Mitchell River Drawbridge

Comments Received By MassDOT
Regarding the Section 106 *Bridge Alternatives
Analysis and Life Cycle Cost Comparison*

This document contains the comments received by MassDOT during the comment period associated with the Section 106 process.

DISCREPANCY IN INFORMATION REGARDING A SINGLE LEAF TIMBER BASCULE

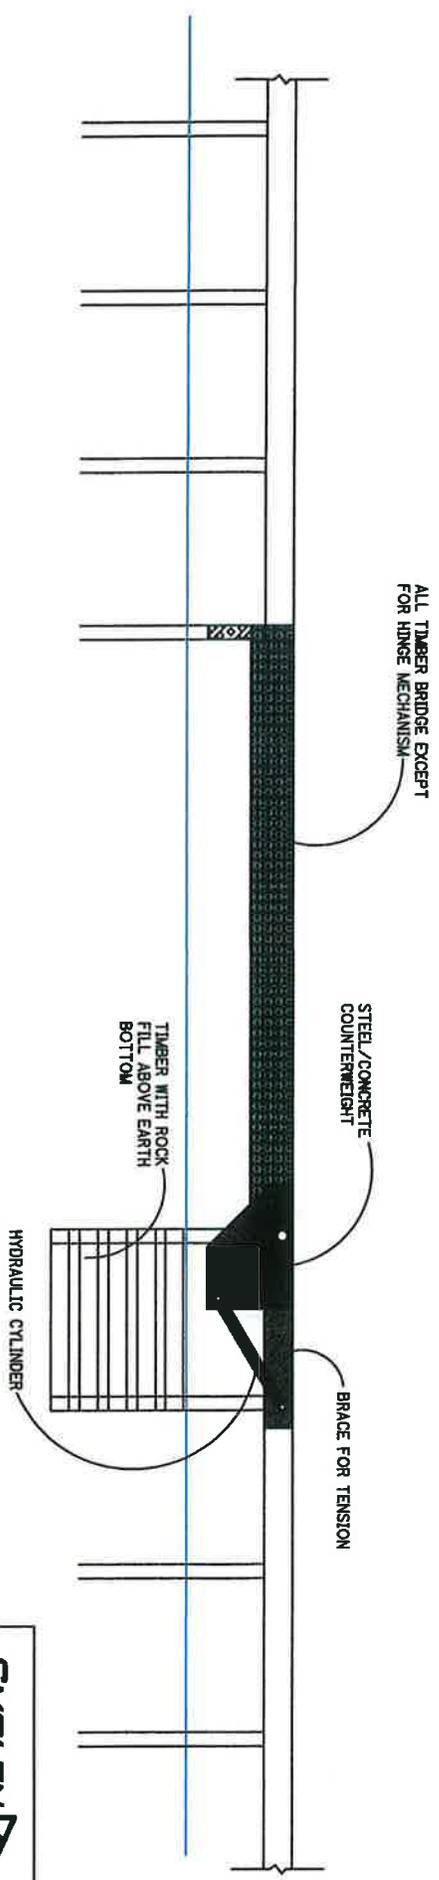
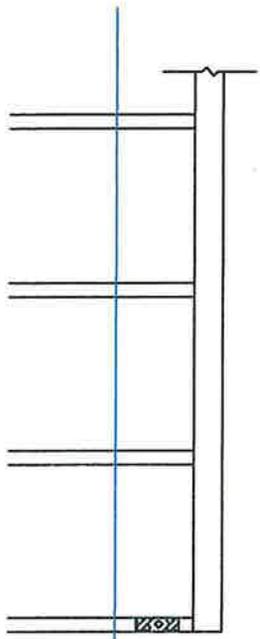
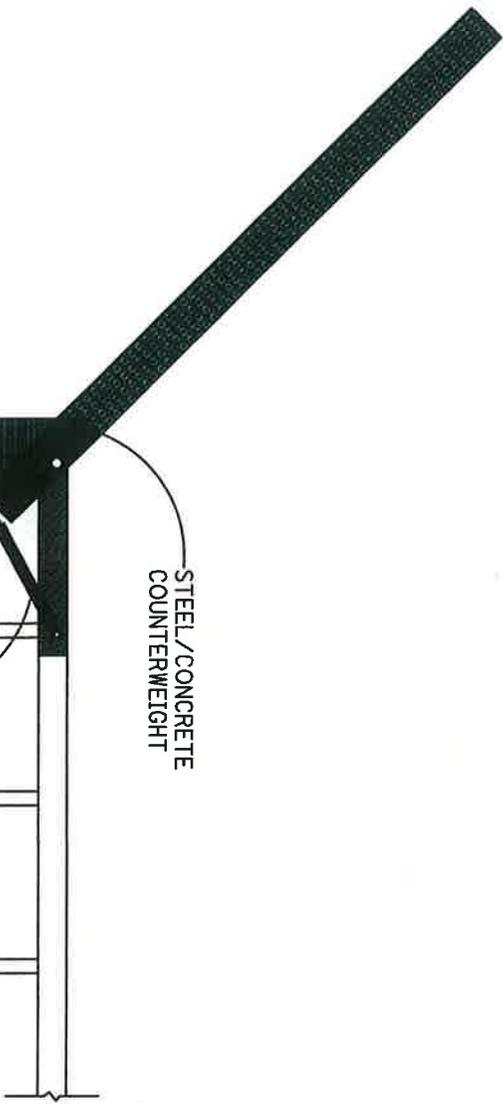
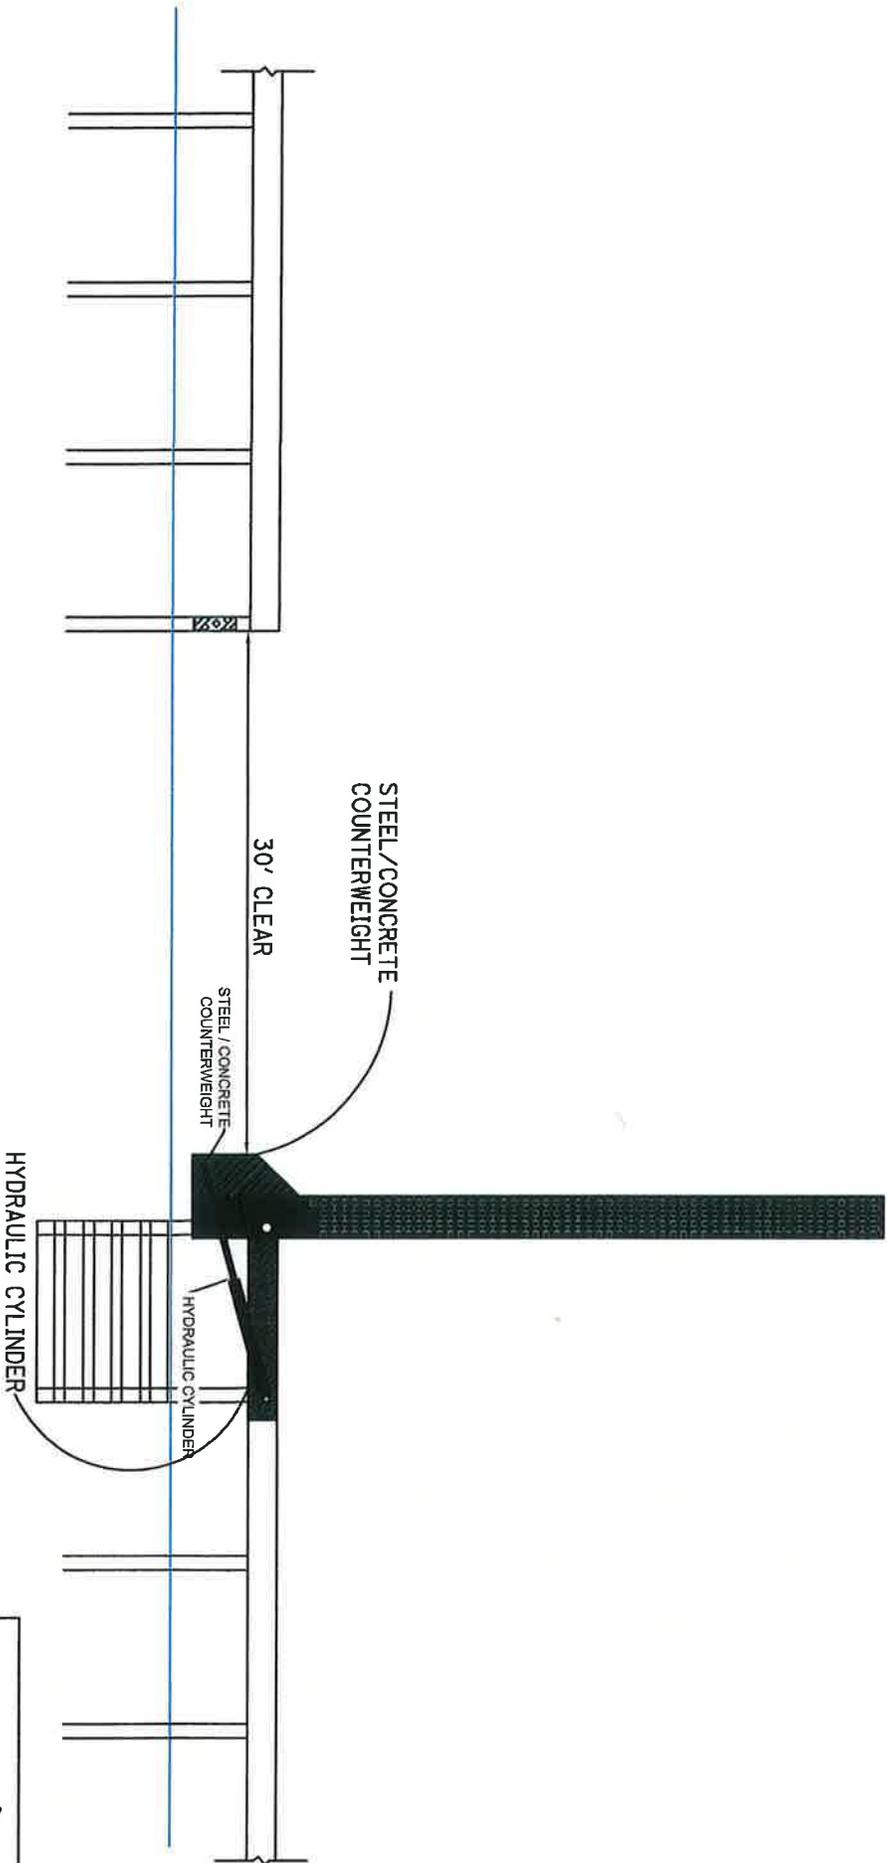
In the MassDOT 2nd Report regarding full replacement of the existing bridge, it is stated as follows:

“Evaluation of the bascule span geometry confirmed that it is feasible to improve the navigation opening with a single-leaf all timber bascule span, similar in appearance to the existing bridge (Alternative 1.) However, the maximum navigation opening with unlimited vertical clearance that can be achieved is 19’4”. Improvements over the existing bridge design can be accomplished by shifting the pivot point back slightly, rotating the leaf to a steeper opening angle, shifting the sheave pole back, and providing a counterweight fabricated using only stainless steel plate (i.e. no concrete) to prevent the counterweight from dipping in the water. Based on comments received, it appears that a navigation opening width less than 25’0” will not adequately serve the boating community in the long term and as a result, the US Coast Guard may be hesitant to permit a bridge with this opening width.” (At p. 33 and see p. 4.) (Emphasis Added.)

Unfortunately, the bascule geometry which is referred to is not included within the Appendices so that the apparent conclusion reached by MassDOT that it is not possible for a timber bascule to support the proposed 25’0” opening can not be reviewed or verified. For this reason, the Friends— immediately upon receipt of the 2nd Report— wrote to FHWA asking for supporting documentation for such statement and conclusion, including the specific geometry involved. As of this date, such information has not been received, although an email from Ms. Damaris Santiago of FHWA to the Friends states that our “comments” will be considered at the Consulting Parties meeting on May 17th. Because of the importance of this information which has a very material effect on the viability of Alternative 1, it is very troublesome that the material has been withheld from us and all of the other consulting parties.

In the interim, however, the Friends have reviewed this conclusion with the engineering firm, Smolen Engineering, Ltd., that is assisting us in this matter. It is their belief that a working timber drawbridge can be constructed to support a navigation opening of 25’0”, and their conceptual sketches are included as part of this submission (copies attached). While they, too, have requested the opportunity to review the bascule geometry which is referred to in the MassDOT Report, it is the existing view of John W. Smolen, P.E., P.S., the principal of Smolen Engineering, Ltd., that from his knowledge and experience, he is confident that a timber bascule bridge is feasible and can be designed to geometric, navigational, mechanical, and structural capacity standards for this site. Mr. Smolen’s background is historic bridge rehabilitation, and he is responsible for designing 200 bridges located in 12 Ohio counties. A copy of his curriculum vitae is attached.
